# Access Compliance Report

## Public Rights-of-Way

### (Curb Ramps)

Intersection ID: 10020967	Main Street: BENSEVAL_LN	Cross Street: N/A	Location: E
ADA ID: BDE8383875EB	Ramp Type: Perp	Initial Pass/Fail: Fail	Overall Compliance: No
Severity Score: 10			
Codes/Mitigation Info/Possible Solution		Field Measurements/Component Compliance

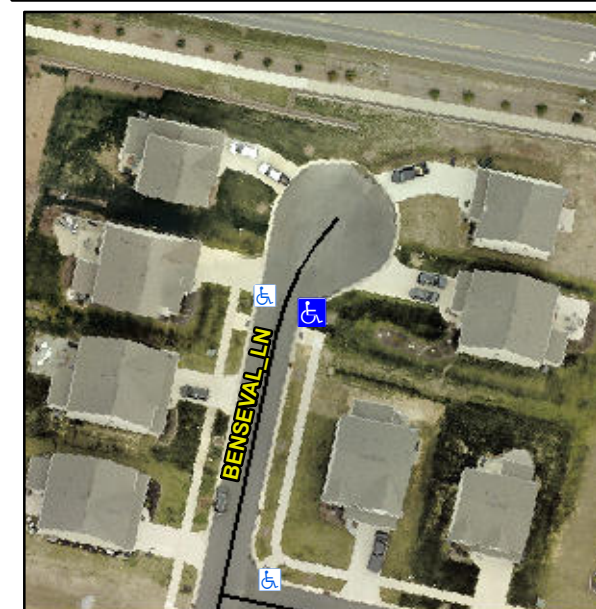
Compliance	Description	Data	Compliance	Description	Data
N/A	Ramp Length (in)	96.0	Yes	Ramp Slope (%)	6.8
No	Ramp Width (in)	47.5	Yes	Ramp XSlope (%)	2.6
N/A	Flare Type LT	N/A	N/A	Flare Type RT	N/A
N/A	Flare Slope LT (%)	N/A	N/A	Flare Slope RT (%)	N/A
N/A	Flare Traversable LT?	N/A	N/A	Flare Traversable RT?	N/A
N/A	Landing Length (in)	N/A	N/A	DWS Provided?	N/A
N/A	Landing Width (in)	N/A	N/A	DWS Contrast?	N/A
N/A	Landing Slope (%)	N/A	N/A	DWS Length (in)	N/A
N/A	Landing X Slope (%)	N/A	N/A	DWS Full Width?	N/A
N/A	Landing Curb? (Y/N)	N/A	N/A	DWS Offset (in)	N/A
N/A	Shared Landing?	N/A			
N/A	Gutter Ponding?	N/A	N/A	Gutter Slope (%)	N/A
N/A	Gutter Lip Ht (in)	N/A	N/A	Gutter X Slope (%)	N/A
N/A	Painted X Walk1?	No	N/A	Painted X Walk2?	N/A
	X Walk 1 Direction	To W		X Walk 2 Direction	N/A
N/A	X Walk 1 Width (in)	N/A	N/A	X Walk 2 Width (in)	N/A
	X Walk 1 Slope (%)	4.1		X Walk 2 Slope (%)	N/A
	X Walk 1 X Slope (%)	2.9		X Walk 2 X Slope (%)	N/A

**Remove & Replace Entire Ramp.**

**R304.5.1**
